Workshop Manual

electrical wiring SUPPLEMENT

CARISMA2003

This publication contains information on major changes which have occurred as a result of modifications for the year model CARISMA.

4G1 <R.H. drive vehicles>

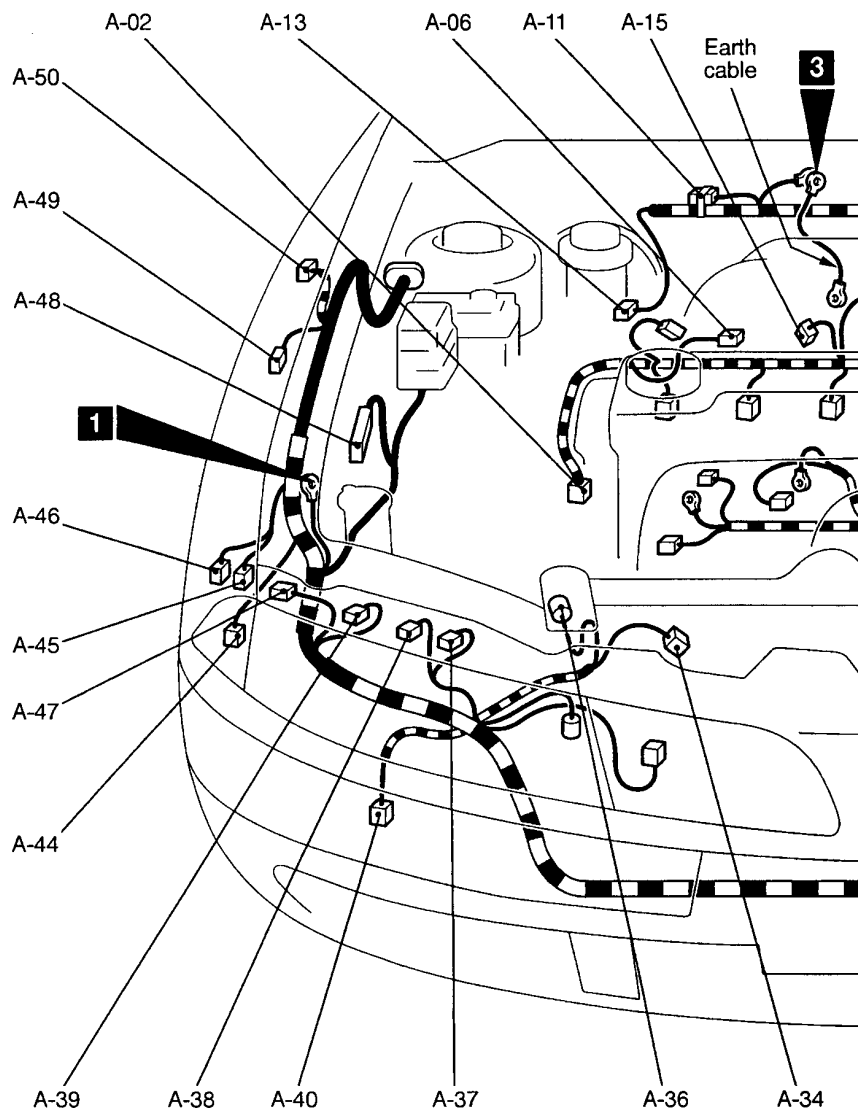
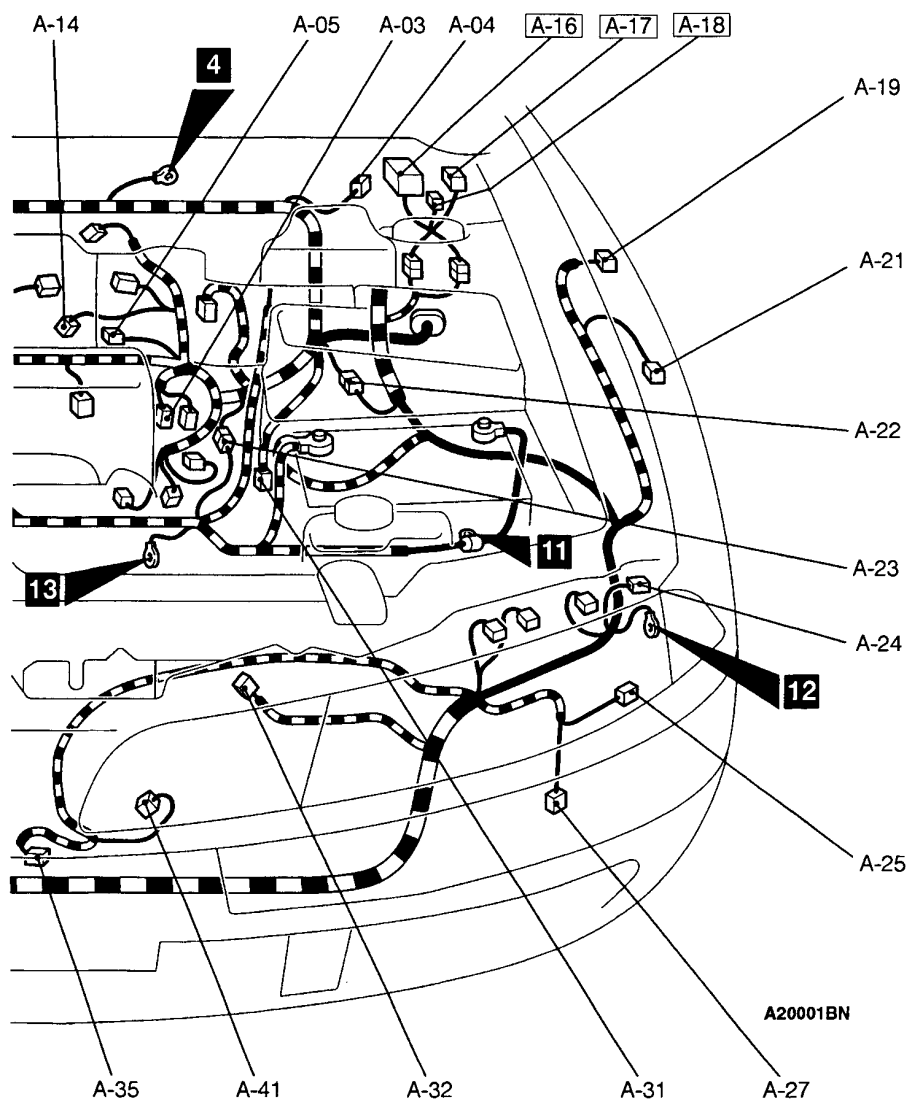
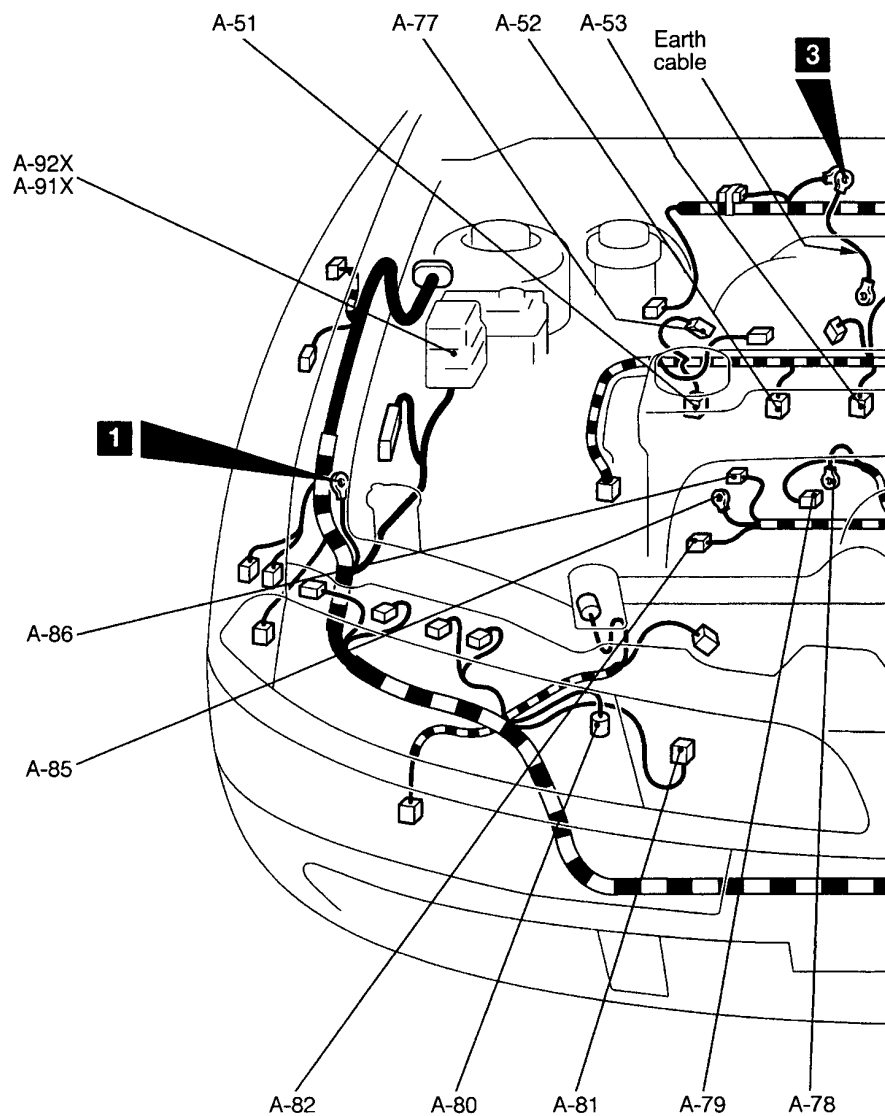
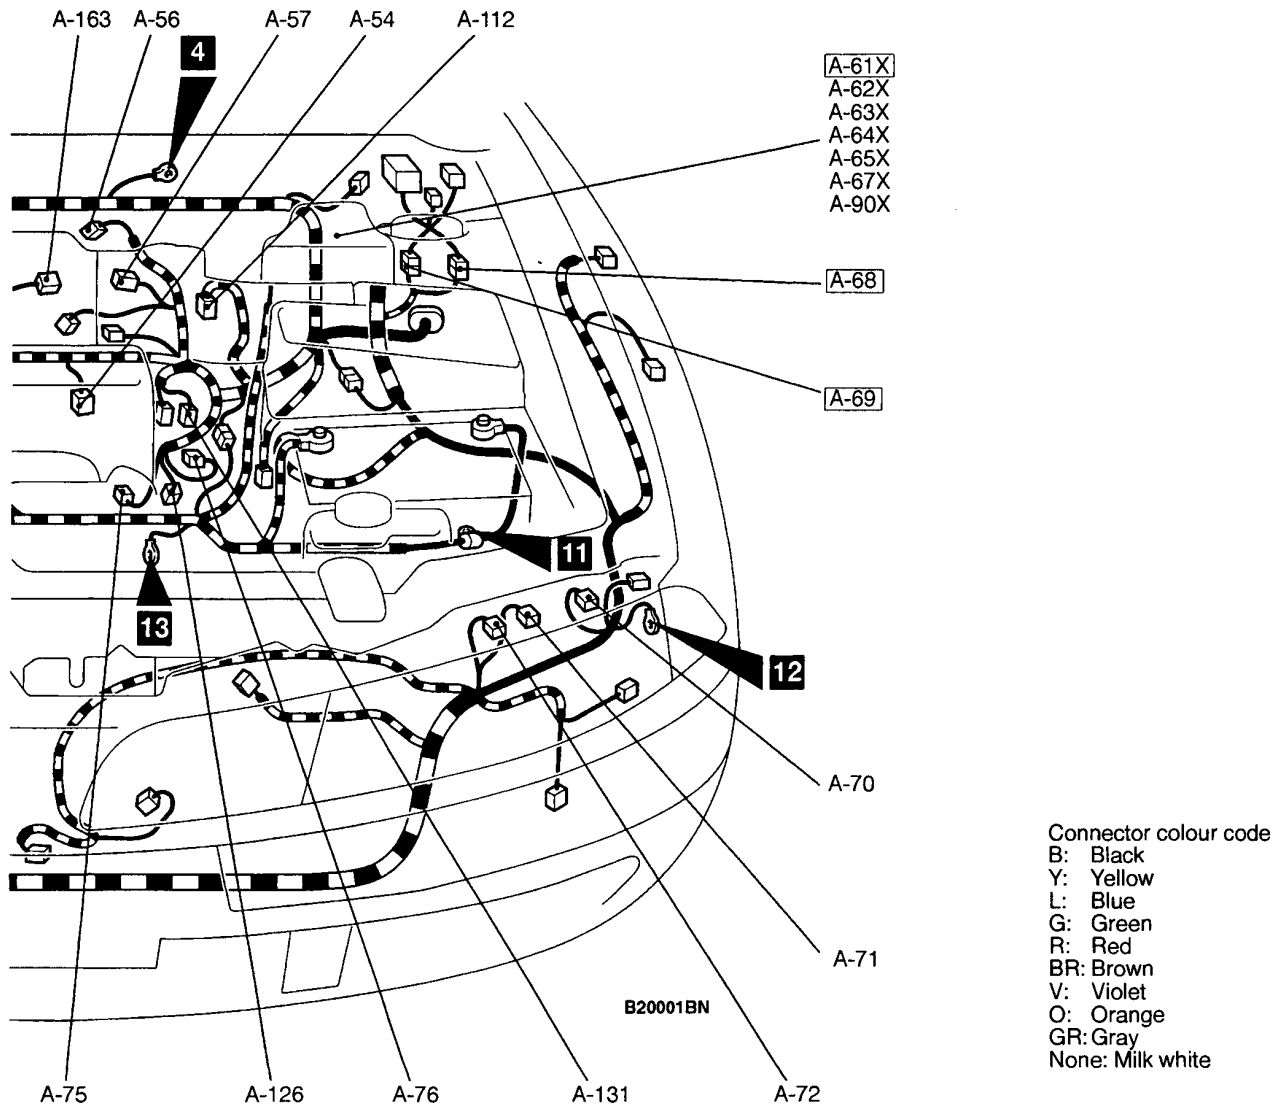
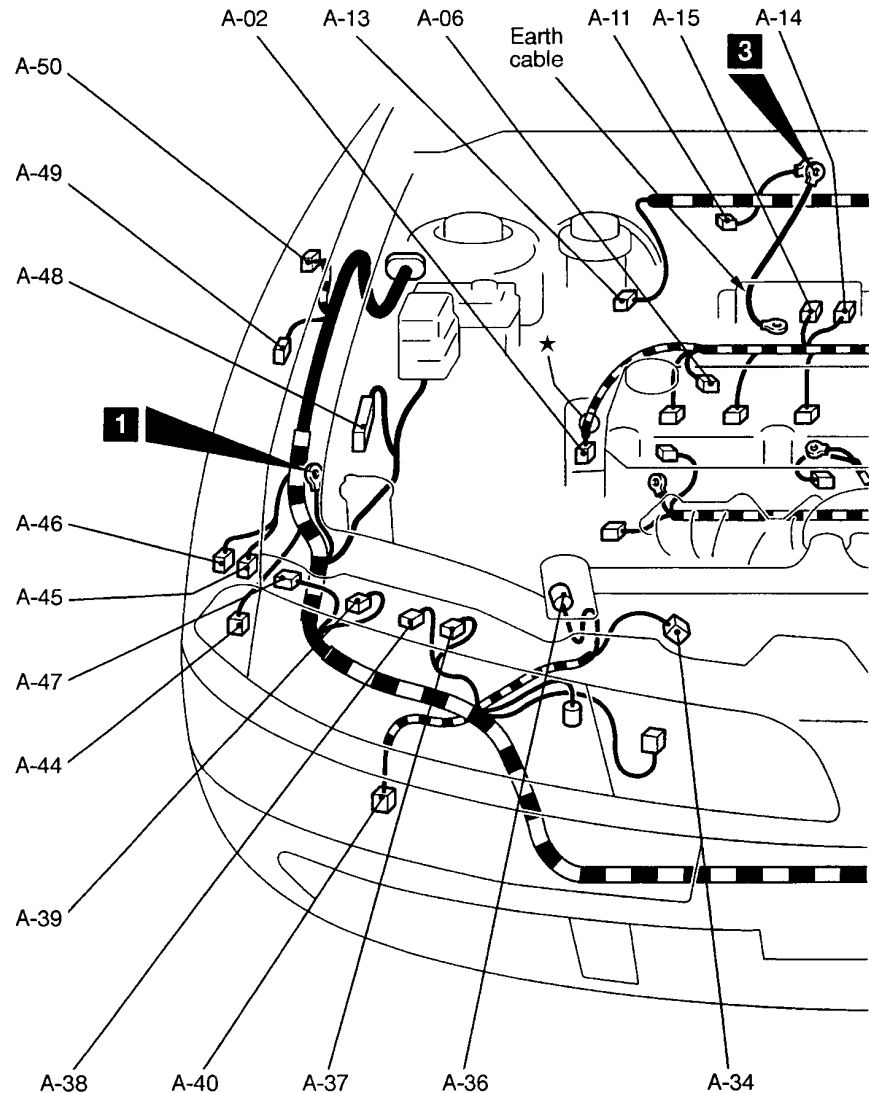
Connector symbol	Name		Reference page	Description of changes
A	ENGINE COMPARTMENT	4G1 <L.H. drive vehicles>	–	The washer fluid level sensor connector (A-43) has been abolished.
		MPI-4G9 <L.H. drive vehicles>	–	
		GDI <L.H. drive vehicles>	–	
		4G1 <R.H. drive vehicles>	2-2	- The following connectors have been added to correspond to the addition of vehicles with DRL. - DRL-ECU (A-16) - DRL relay 1 (A-17) - DRL relay 2 (A-18) - Tail lamp relay <DRL> (A-61X) - Front wiring harness and DRL wiring harness combination (A-68, 69)
		MPI-4G9 <R.H. drive vehicles>	2-6	
		GDI <R.H. drive vehicles>	2-10	
		Diesel <F9Q-L.H. drive vehicles>	–	
		Diesel <F9Q-R.H. drive vehicles>	2-16	
D	FLOOR AND ROOF	L.H. drive vehicles	–	The name of D-05 connector has been changed from the sunroof-ECU to the sunroof assembly due to the change of the sunroof system.
		R.H. drive vehicles	–	
E	DOOR	L.H. drive vehicles	–	- The following connectors have been abolished. - Door lock key cylinder switch (Passenger's side) (E-12) - Tweeter (LH, RH) (E-17, 20)

NOTE
 Connector numbers in are connector numbers which have been added.
